MRP Materials Reliability Program _____ MRP 2010-031
(via email)

SUBJECT: EPRI MRP Final Draft Responses to: REQUEST FOR ADDITIONAL INFORMATION RE: ELECTRIC POWER RESEARCH INSTITUTE TOPICAL REPORT 1016596, 'MATERIALS RELIABILITY PROGRAM: PRESSURIZED WATER REACTOR INTERNALS INSPECTION AND EVALUATION GUIDELINES (MRP-227-REV. 0)' (TAC NO. ME0680), November 12, 2009

**Final Draft
Responses to 3rd Set RAIs
On MRP-227, Rev 0**

Figure 2.1 from MRP-227

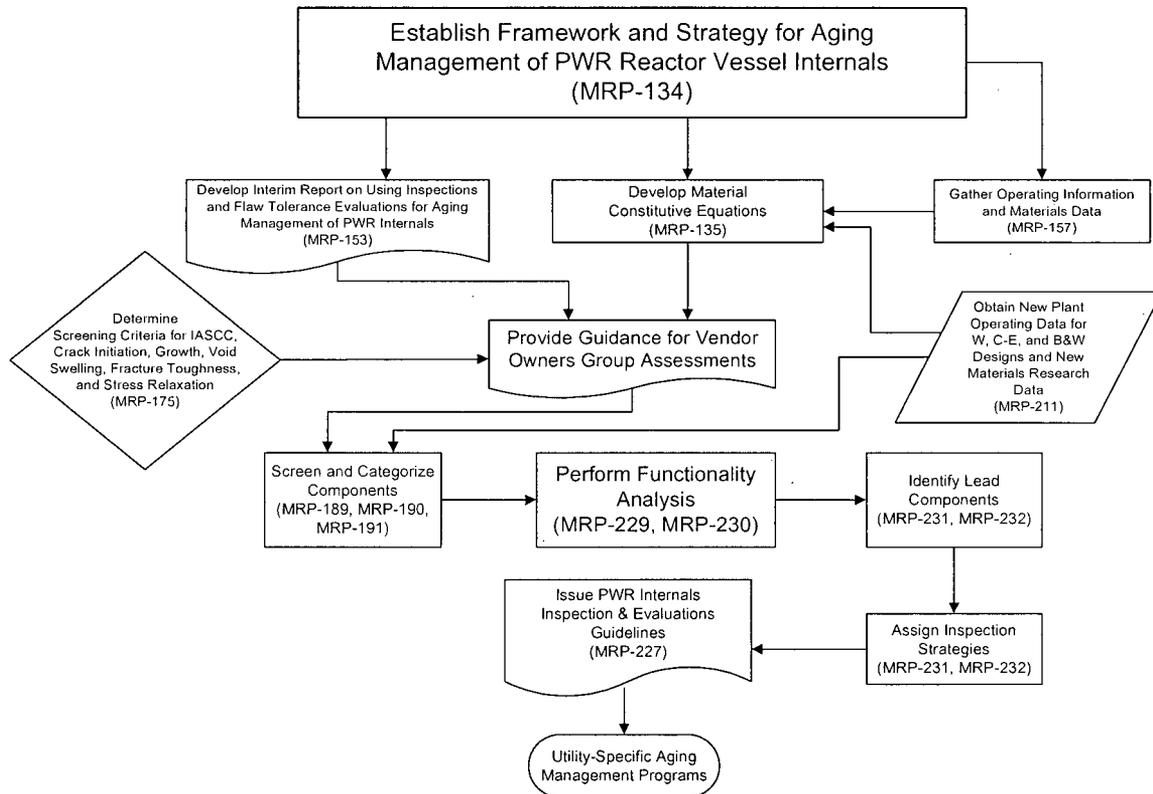
RAI 3-1 It is not evident to the NRC staff whether or not the inspection and evaluation (I&E) methodology in TR MRP-227-Rev. 0, or in other MRP report methodologies that support the TR MRP-227, Rev. 0, methodology, are:

Perform a comparison of the recommended I&E methodology in TR MRP-227, Rev. 0, and its supporting MRP aging management methodologies to the NRC staff's recommended aging effect identification and management guidance in SRP-LR BTP RLSB-1. Demonstrate the compliance of the TR MRP-227, Revision 0, methodology with the requirements of 10 CFR Part 54 and with the NRC staff's recommendations in SRP-LR BTP RLSB-1. In addition, justify any non-compliances of your proposed methodology with the stated requirements in 10 CFR Part 54 or non-conformances with the recommendations in SRP-LR BTP RLSB-1.

MRP-227, Revision 0 summarizes the results of industry programs for investigating and managing these aging effects in reactor internals and provides recommendations for the implementation of those results. A graphical representation of the process is depicted in MRP-227, Revision 0 Figure 2-1. The MRP-227, Revision 0 methodology begins with an extensive effort to identify materials, environment, stresses, service conditions, operating experience and other relevant information as required by SRP-LR BTP RLSB-1. This initial effort is described in MRP-134, MRP-135, MRP-153, MRP-157 and MRP-211. The second step in the process defines screening criteria that can be used to identify conditions that can potentially result in component degradation. Screening criteria were developed for eight relevant degradation mechanisms. These relevant degradation modes included the mechanisms identified in the GALL as “AMR Results for Which Further Evaluation is Recommended.” Each component was compared to the MRP-175 screening criteria to identify applicable aging effects. The results of the screening process are reported in MRP-189, Revision 1 and MRP-191. This screening process is integral to the AMR and should not be confused with the screening process used to identify passive components per 10 CFR Part 54.21(a)(1).

The transition from “applicable aging management effects” represented by MRP-189, Revision 1, MRP-190, and MRP-191 to “aging management program elements” is provided by MRP-231 and MRP-232, from which the requirements of MRP-227, Revision 0 were extracted and refined. The inspection guidelines provided in Section 4 of MRP-227, Revision 0 provide the basis for the program elements required in an AMP. Appendix A of MRP-227, Revision 0 summarizes the AMP Program Attributes required by NUREG-1800, Revision 1. The MRP-227, Revision 0 document is intended to provide the technical basis for an AMP. This appendix describes the extent to which the MRP-227 guidelines and supporting documents satisfy the AMP requirements. The MRP has agreed to work with the NRC to have these AMP recommendations incorporated in the upcoming GALL revision.

Figure 2.0-1
LICENSE RENEWAL IMPLEMENTATION PROCESS

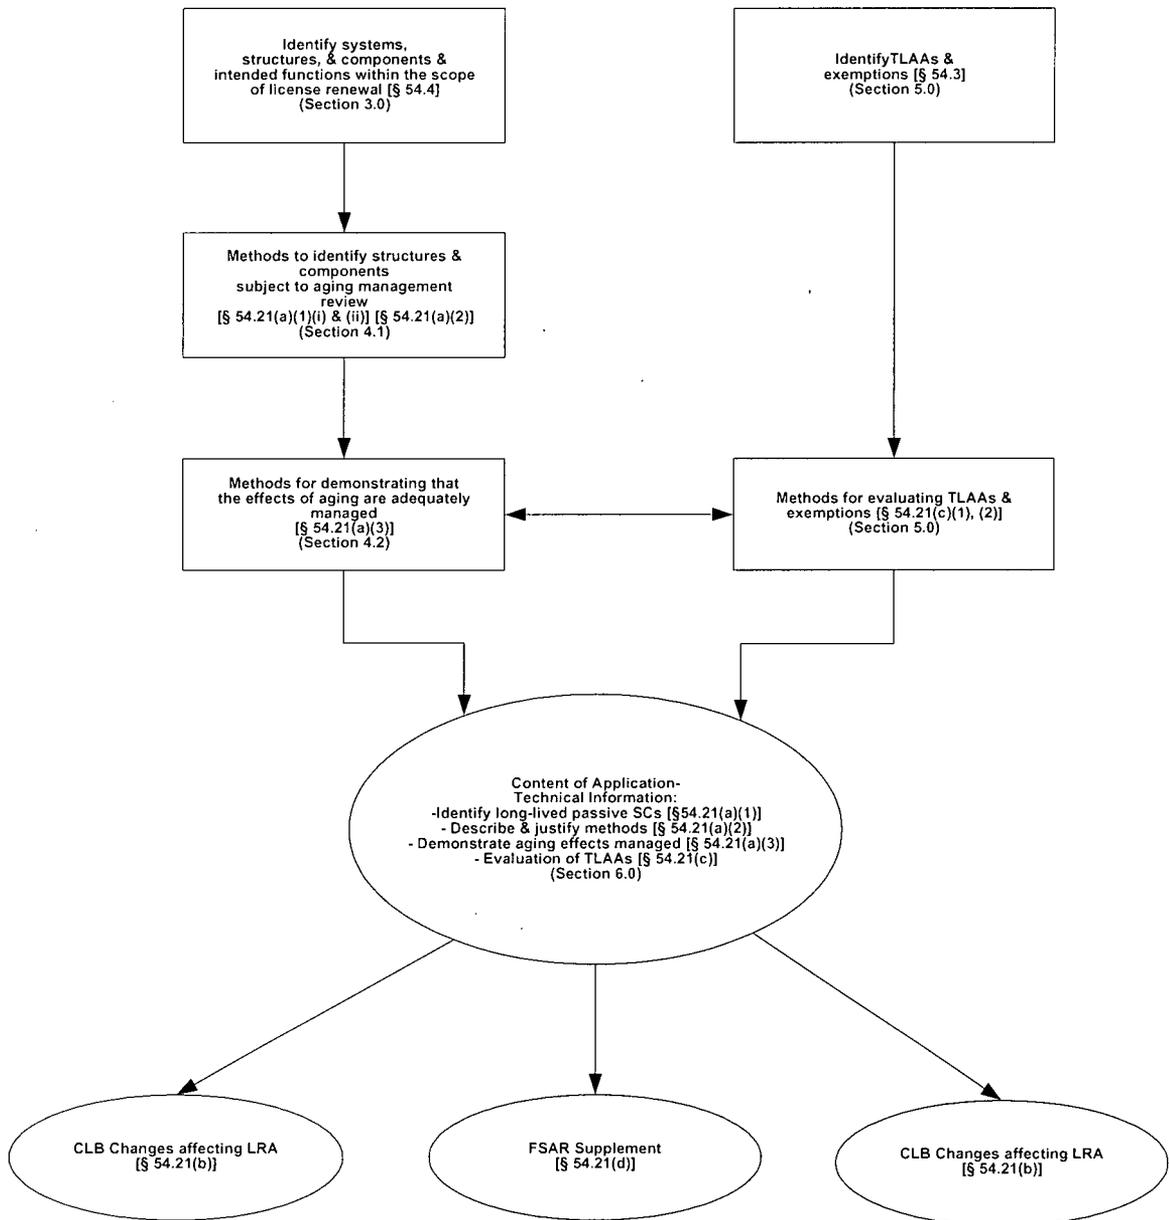
RAI 3-2 TR MRP-227, Rev. 0, does not make reference to Nuclear Energy Institute (NEI) Report No. NEI 95-10, Revision 6,² 2 as an applicable industry license renewal report; nor does TR MRP-227, Rev. 0, provide any discussion on how it will be used to conform to the recommendations in NEI 95-10, Rev. 6, when implementation of the I&E recommendations are applied as license renewal activities and methods for aging management of RVI components. Discuss how and provide the basis for why the recommended I&E scoping/screening process, inspection activities, evaluation methods and acceptance criteria in TR MRP-227, Rev. 0, are considered to be in conformance with the recommendations in NEI 95-10, Rev. 6, paying particular attention to conformance with Chapters 2, 3, and 4 of the NEI 95-10, Rev. 6, and the license renewal processes identified therein for implementation in Figures 2.0-1, 3.0-1, 4.1-1, 4.2-1, and 4.3-2.

The overall license renewal process is outlined in Figure 2.0-1. There are two major branches in Figure 2.0-1. The first branch describes aging management activities including the development of AMRs and associated AMPs. The second branch describes the process used for Time Limited Aging Analysis (TLAA). MRP-227, Revision 0 and its supporting documents provide the technical basis for aging management of systems structures and components within the reactor internals. This objective of the MRP effort was to provide documents that would support utilities in the implementation process and allow appropriate revisions to the NUREG-1801, Revision 1 (GALL) report. While MRP-227, Revision 0 is not intended to follow the implementation process precisely, it certainly supports the aging management branch of the license renewal process. Its recommendations are consistent with the intent of the process and assure utility conformance in the license renewal process.
